# Exception Review Committee Public Hearing

#1996-WRPA-016-1

Water Quality Impact Assessment #1996-WQ-005-1

917 Whann Avenue,  
McLean, Virginia

# Staff - Summary of the issues (2)

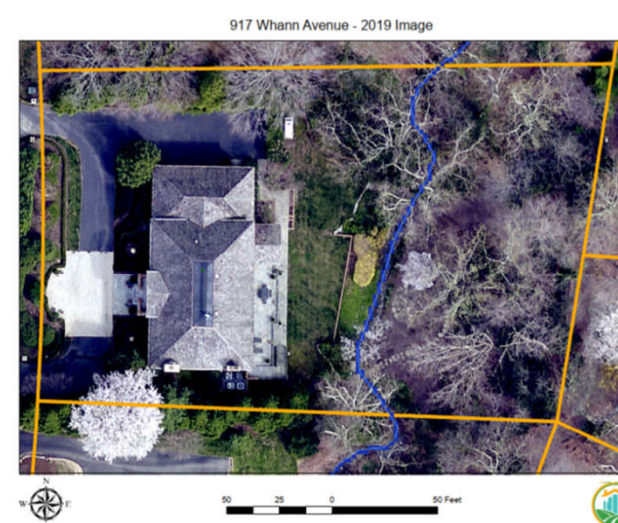
- The applicant wishes to Install an in-ground swimming pool (18 x 13) and spa with a deck on previously leveled ground.
- The proposed increase in impervious is 998 square feet.
- The application is submitted under 118-6-8.
- Disturbance in the seaward 50-feet is proposed.
